# SERVICE BULLETIN

No. 272A

Security of Electrical Terminal Screws - Voltage Regulator Selector Switch and Master Switch

PA-31 Navajo

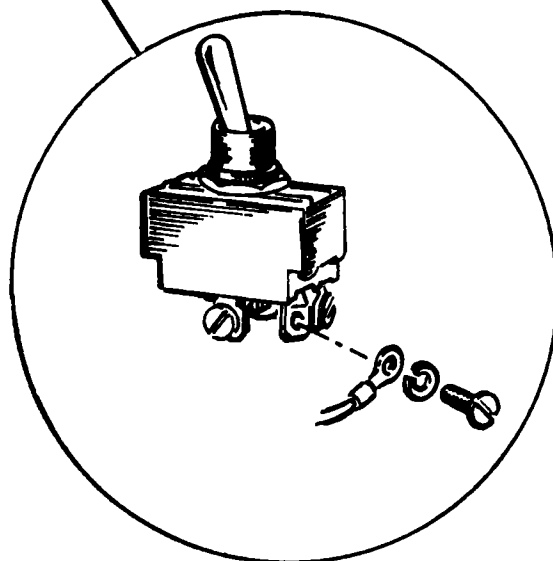
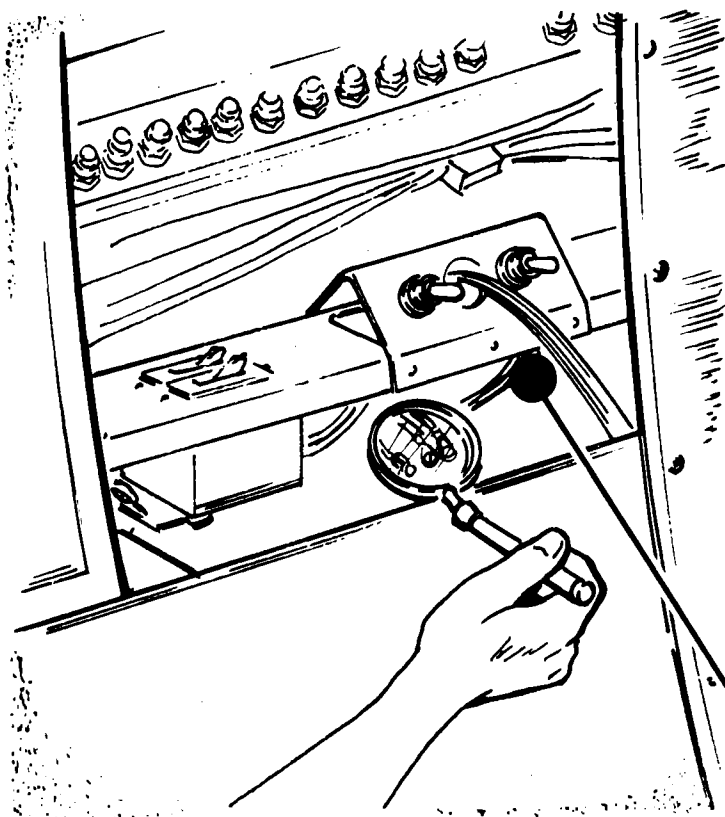
Carefully remove the royalite cover from the main switch and circuit breaker panel. Using a flashlight and mirror, visually inspect the electrical terminals on the subject switches to determine if lock washers (AN935-6; Piper part number 407 102) have been installed under the head of each terminal screw. (See sketch on reverse side of this bulletin.)

If inspection determines that lock washers are not installed under the head of each terminal screw, remove the knurled ring nut from the toggle switch, drop the switch down through the switch mounting bracket and install necessary lock washers to insure that the switch is complete with one each lock washer under the head of each terminal screw.

Part number 407 102 (AN935-6) lock washers - as required.
